Report: TAB REPORT
Function: Test, Adjust, & Balance
Date: 08/01/2024

PROJECT
06-17-24 CAVA YUKON, OK (10TH ST)

Issue List

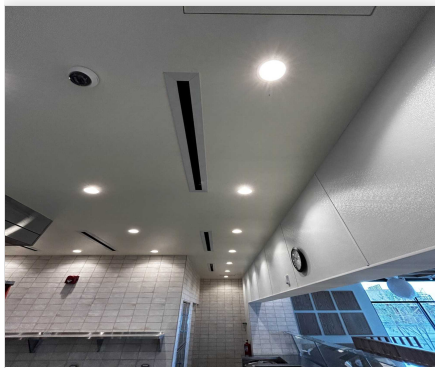
Issue Name : EF2 - AIRFLOW
Description : FAN IS ON HIGH AIRFLOW, NO FAN SPEED CONTROLLER INSTALLED. RECOMMEND INSTALLED SPEED CONTROLLER TO BRING FAN INTO DESIGN.
Created By : National TAB **Assigned To :** National TAB - Will Turnbough
Status : Open
Priority : Urgent **Asset Tag :**
Originated Date : 06/19/2024 - Kristopher Passley - National TAB

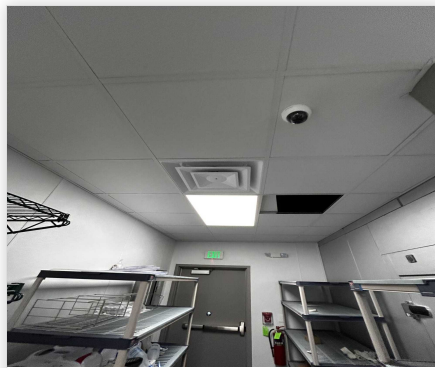
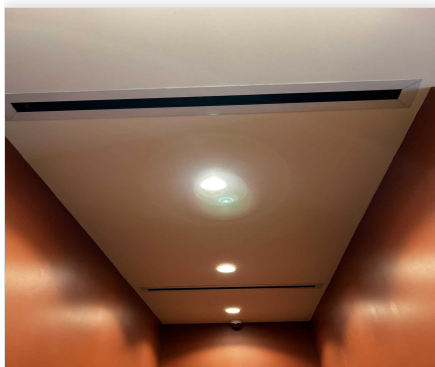
Issue Name : RTU-1 KITCHEN DIFFUSERS
Description : KITCHEN DIFFUSERS 1-1,1-2,1-3 and 1-8 HAVE CLOSED DAMPERS THAT ARE INACCESSIBLE. NEED MECHANICAL TO OPEN OR CHECK FOR BLOCKAGE.
Created By : National TAB **Assigned To :** National TAB - Will Turnbough
Status : Open
Priority : Urgent **Asset Tag :**
Originated Date : 06/20/2024 - Kristopher Passley - National TAB

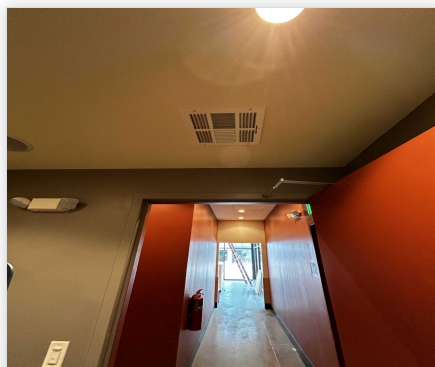
Issue Name : RTU-2 DIFFUSERS
Description : RESTROOM AND HALLWAY DIFFUSERS 2-11, 2-12 and 2-14 HAVE CLOSED DAMPERS THAT ARE INACCESSIBLE. NEED MECHANICAL TO OPEN DAMPER OR CHECK FOR BLOCKAGE.
Created By : National TAB **Assigned To :** National TAB - Will Turnbough
Status : Open
Priority : Urgent **Asset Tag :**
Originated Date : 06/20/2024 - Kristopher Passley - National TAB
